# ***INSPECTION BULLETIN***

## ***Tank Car Inboard Stub Sill***

### ***Inspection and Modification***

**Application Criteria:** ARI Tank Cars built prior to Oct 1, 2011 with ARI 300 stub sills.

Figure 2

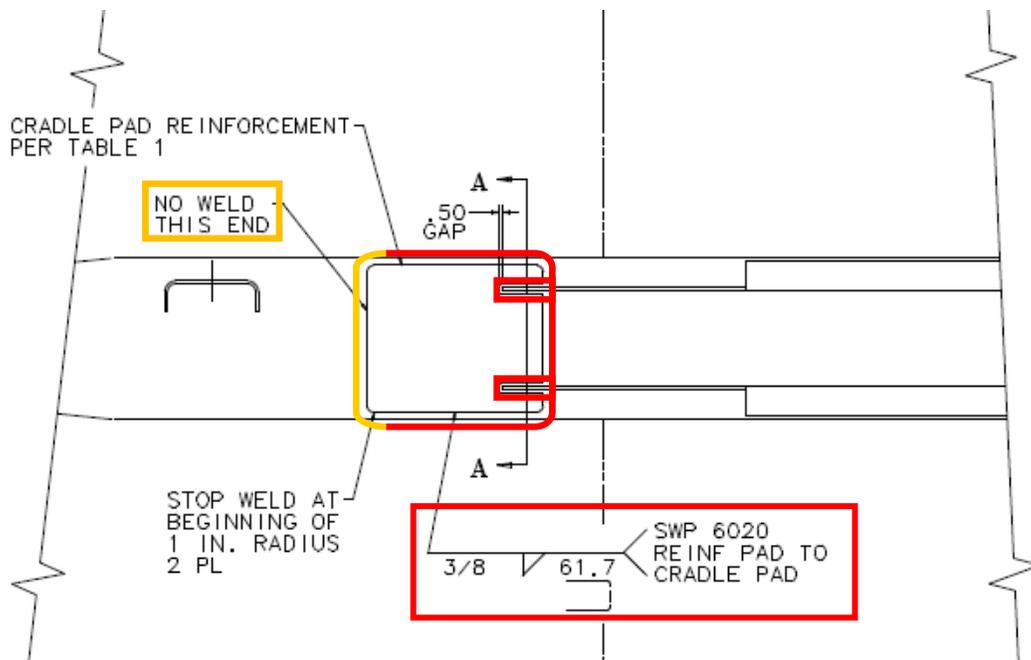
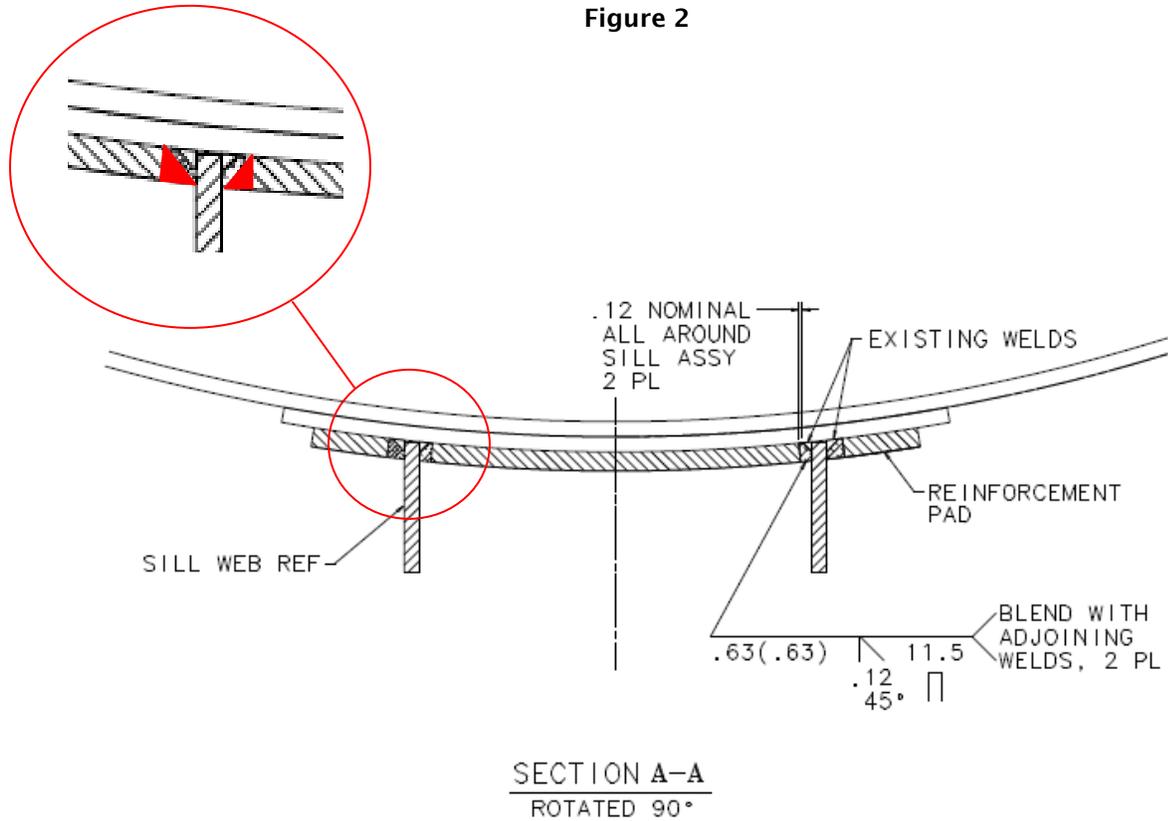
3. Position the cradle pad reinforcement as shown (Figure 2.) The reinforcement may require grinding or trimming to maintain the proper weld joint geometry shown in Figure 2; the weld preparation should be 1/2 inch wide minimum around the draft sill side webs, to allow for the application of a 5/8 inch groove weld.

4. Weld the cradle pad reinforcement to the draft sill and cradle pad per Figure 2, using an E-7018 electrode or equivalent. All Welding is to be in accordance with AWS D15.1, and the AAR Manuals of Standards and Recommended Practices Appendix W.

**DO NOT WELD THE INBOARD TRANSVERSE END OF THE REINFORCING PAD.**

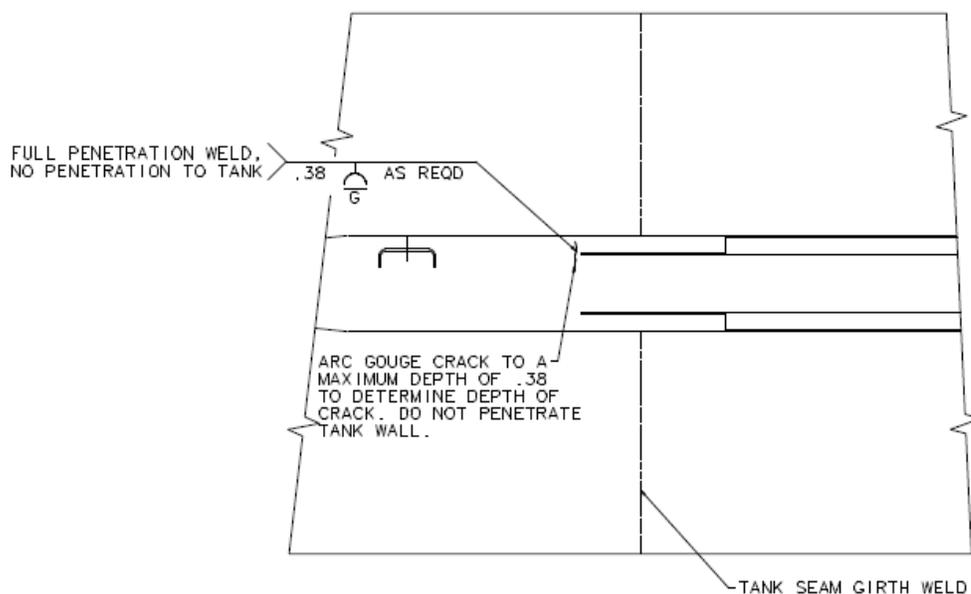
- i. Dye Penetrant inspect the full length of the crack removal area to ensure the crack has been completely removed.
- ii. Weld repair the crack by groove welding, ensuring that there is no penetration to the tank shell (Figure 3.)
- iii. Welding is to be performed using an E-7018 electrode or equivalent. All Welding is to be in accordance with AWS D15.1, and the AAR Manuals of Standards and Recommended Practices Appendix W.
- iv. Grind the weld flush with the cradle pad surface.

Figure 6

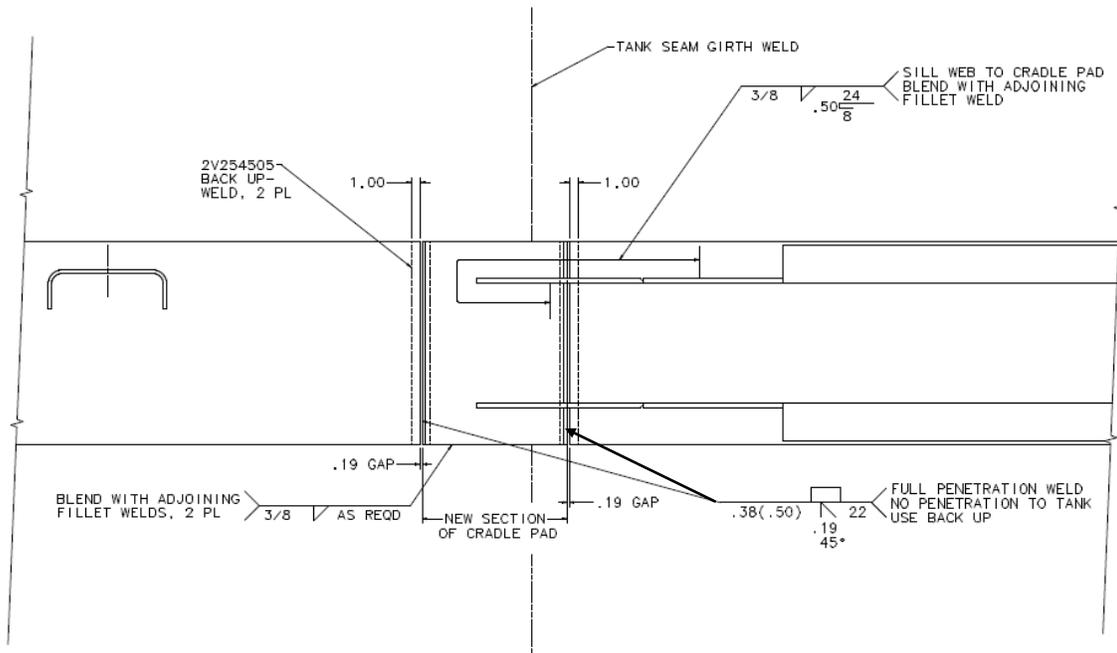
- viii. Fabricate a cradle pad splice in the same thickness as the removed cradle pad; material is ASTM A572 Gr. 50 modified to 70,000 psi tensile and rolled to match tank diameter. Apply weld prep on the transverse edges of the cradle pad splice as shown in the weld in Figure 6.

- ix. Groove weld the cradle pad splice section into place per Figure 6. The transverse welds are to be full penetration groove welds using the backing applied in 2.B.vi above to prevent penetration to the tank. Fillet weld the longitudinal edges of the cradle pad to the tank with 3/8 inch fillet welds including the 6 inch tie in created at the original cradle pad on the inboard and outboard ends of the cradle pad splice.

Figure 7

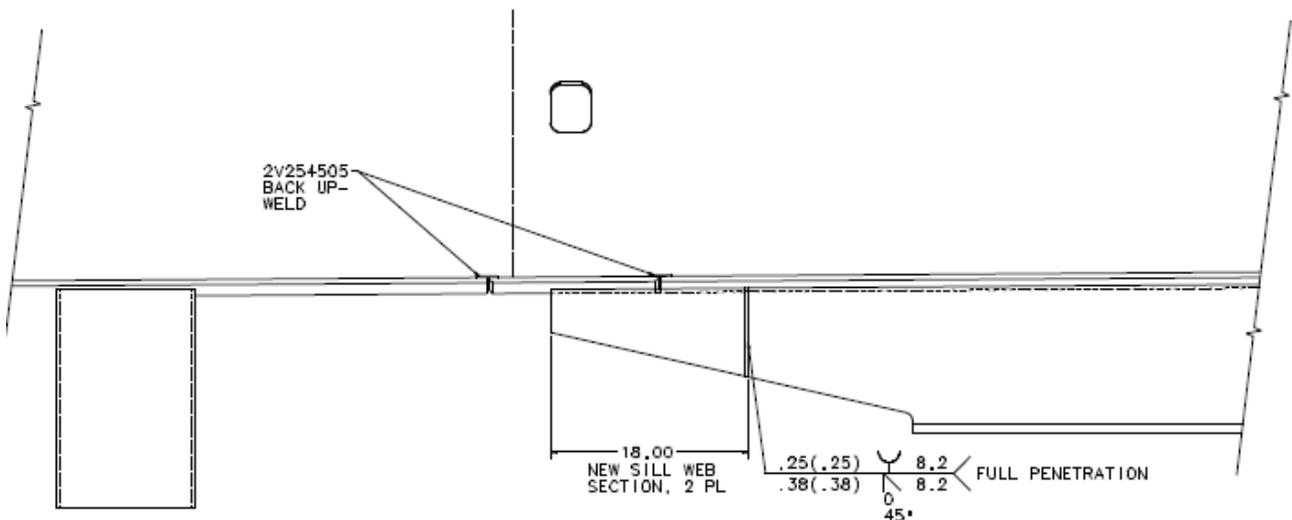
- xi. Local post weld stress relieve welds to tank shell.
- xii. Inspect the repair welds after stress relief with Dye Penetrant.
- xiii. Re-apply the draft sill side web sections removed in part 2.B.i. 100% penetration butt weld the vertical weld joint per Figure 7.
